## Memorandum

By: Roger Dickinson, P.E, PTOE  
Date: December 12, 2011  
RE: Hinesburg Hannaford

To: David White  
From: Roger Dickinson, P.E, PTOE  
Date: December 11, 2011  
RE: Rick Bryant's August 8, 2011 Memorandum

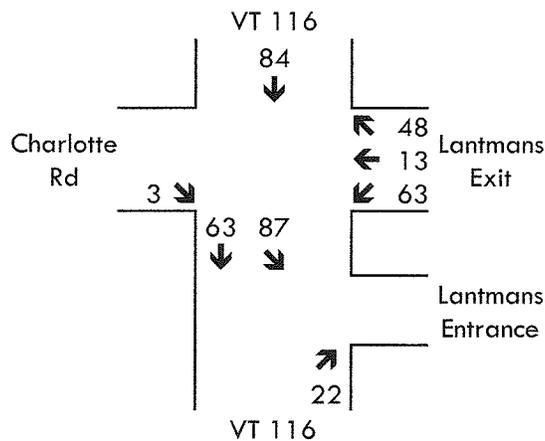
#2 - Historical traffic counts at the VT 116/Charlotte Road intersection were examined to compare traffic patterns entering and exiting Lantman's. Those counts include a 2010 turning movement count performed by the CCMPO, and 2003, 2008 and 2009 turning

movement counts performed by VTrans. While only the 2009 VTrans count included traffic entering Lantman's, all four included traffic exiting Lantman's. In examining traffic count data, one must keep in mind that they do not differentiate between primary and pass-by trips. PM peak hour traffic patterns exiting Lantman's are compared in the following table:

In comparing the two sets of directional patterns, one must take into account the different locations of Hannaford vs. Lantman's, particularly with respect to trips to/from the northeast via Mechanicsville Rd and to/from the west via Charlotte Rd. With those differences accounted for, the proposed Hannaford directional patterns compare favorably to Lantman's existing directional patterns.

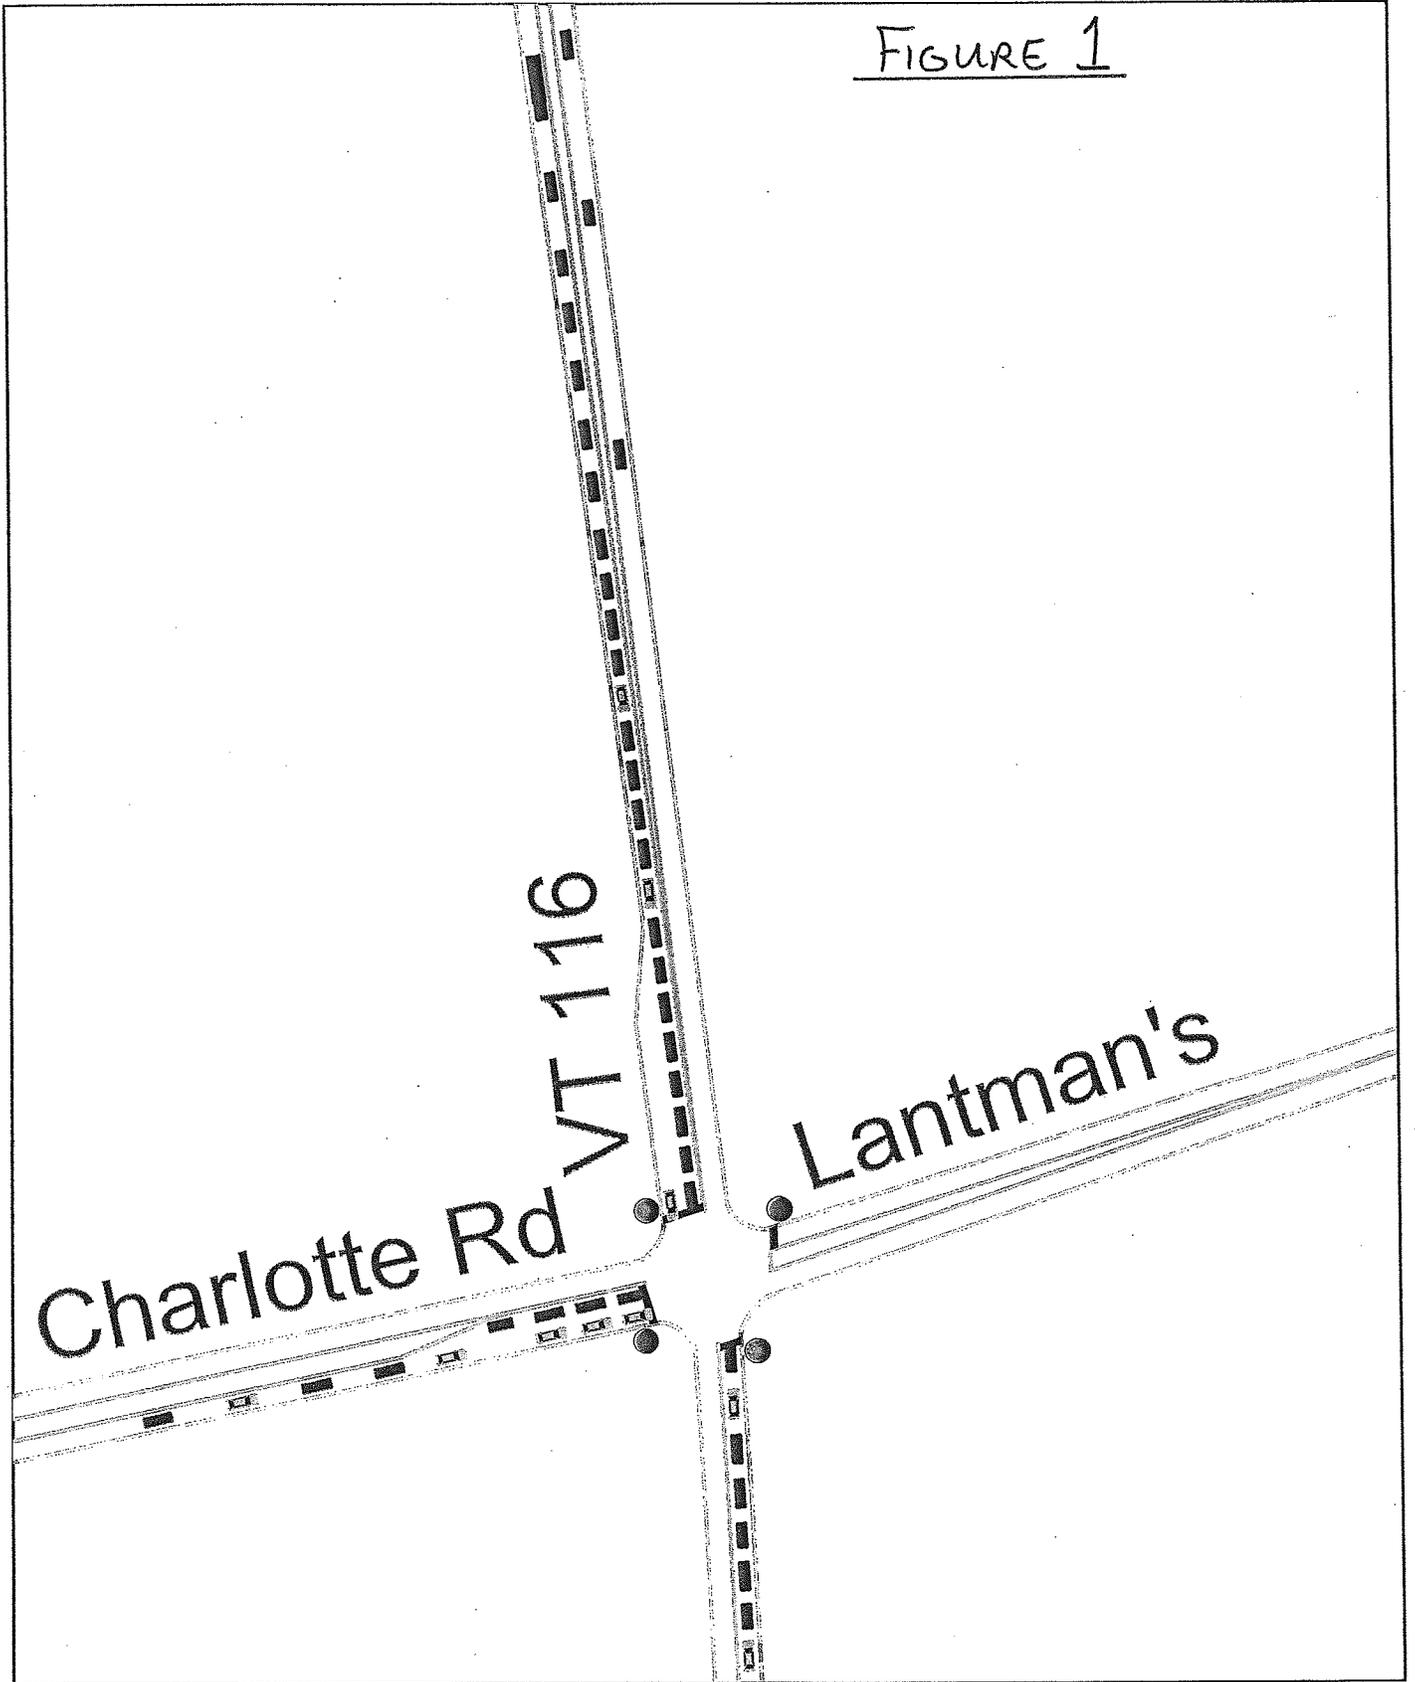
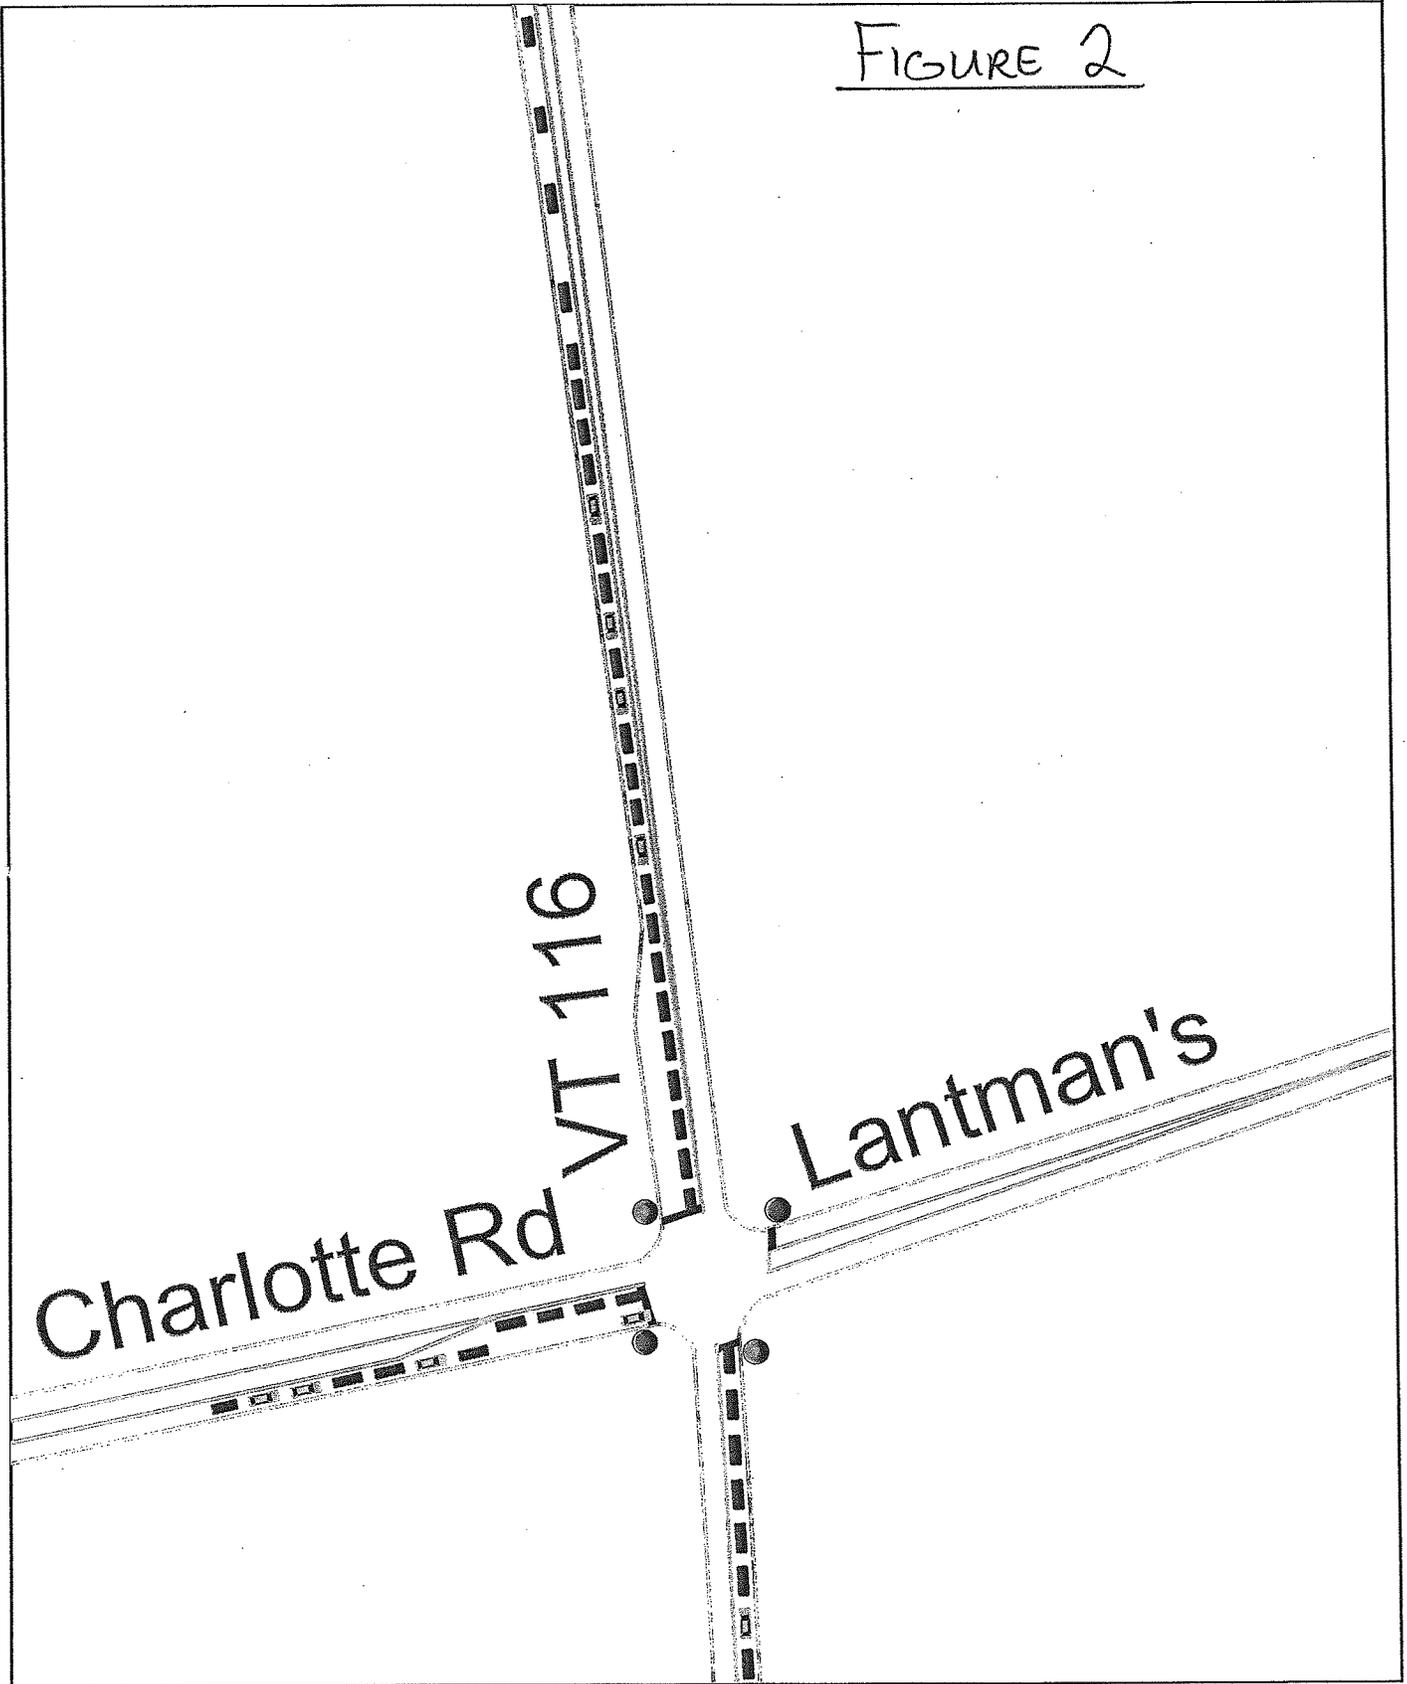
As requested at Monday's (October 31<sup>st</sup>) meeting, enclosed is an intersection sketch showing turning paths of a WB-67 exiting Charlotte Rd and a WB-50 exiting Lantman's simultaneously (in the extremely rare case this would ever occur).

Examining southbound traffic patterns at this intersection indicates that this will not be the case. A field review of existing utility locations determined that attempting to construct anything longer than an 100 ft long right-turn lane having an 180 ft entry taper on the southbound approach will likely encounter severe (and very expensive) utility conflicts. Those lengths were used to perform multiple SimTraffic microsimulations.

The results of those simulations indicated that entry to the right-turn lane would be effectively blocked 31% of the time. This may not seem to be a lot, but it primarily occurs during the critical red time when vehicles need to enter that lane in order to effectively relieve existing pm peak hour congestion on VT 116. Figures 1 and 2 illustrate the prevailing inability of vehicles to enter the right-turn lane. Both illustrations were captured right at the point when the VT 116 NB/SB signal phase turns green. Southbound right-turning vehicles waiting in the VT 116 queue are shown as yellow-colored vehicles.

Figure 1 - 2017 No-Build Queues

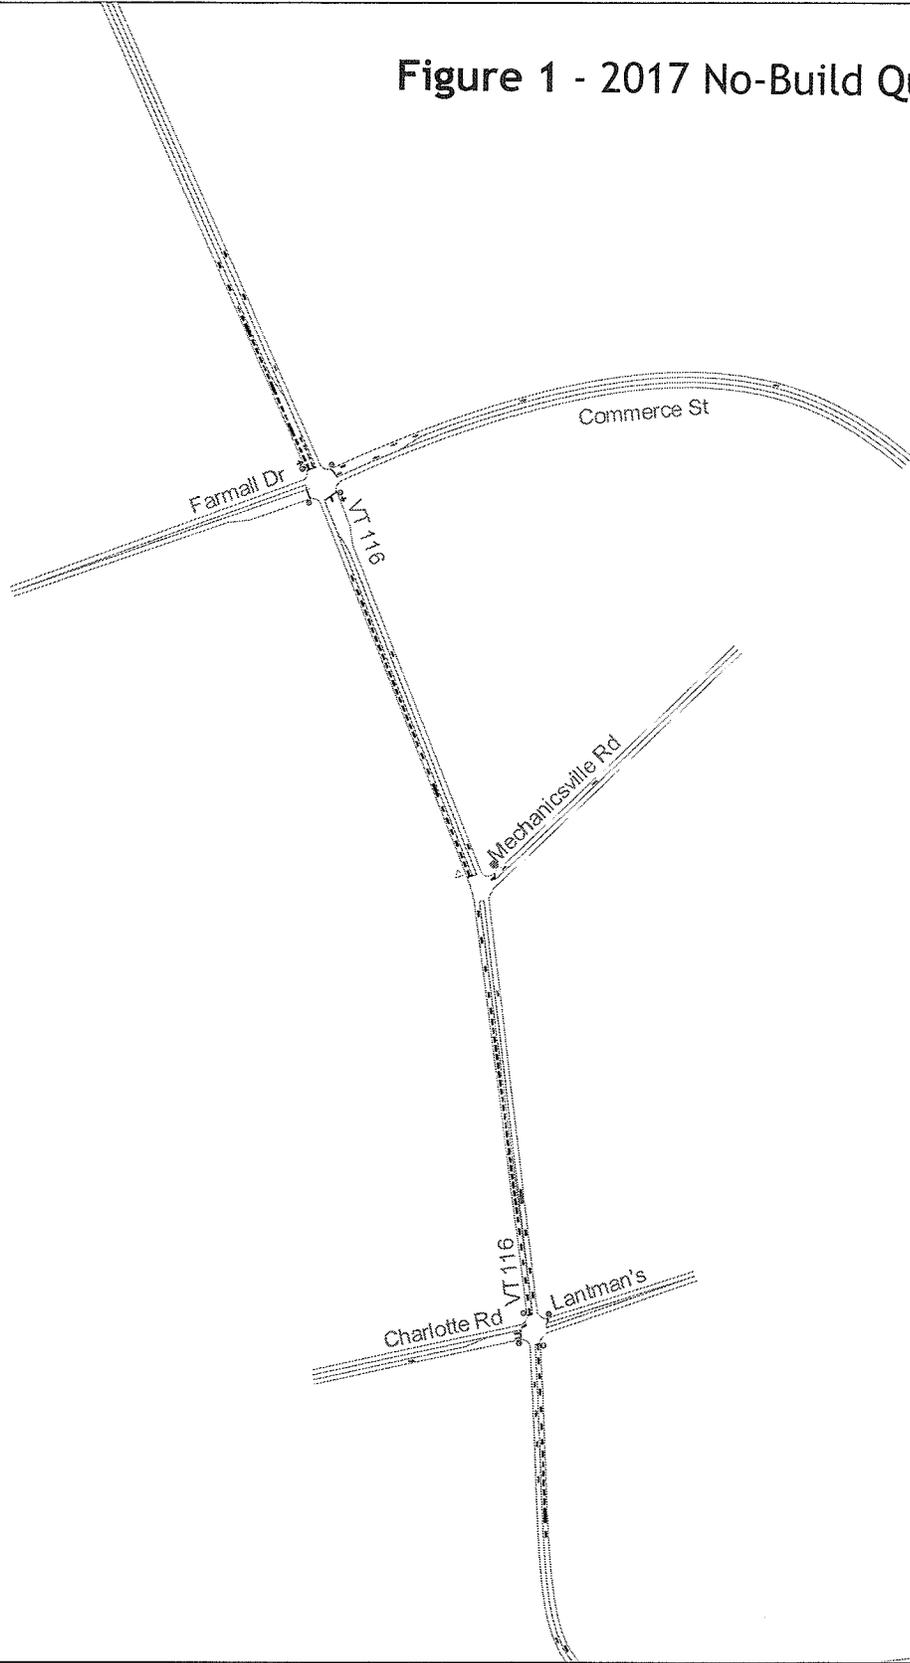
Table 1 presents the results of the simulation modeling for this Project. The average results of the recommended minimum of five simulation runs are presented in order to minimize the normal variances inherent in any one simulation run. Changes in the maximum queue lengths

between the No-Build and Build scenarios are also readily apparent by comparing Figures 1 and 2 which are appended hereto as Attachment C.
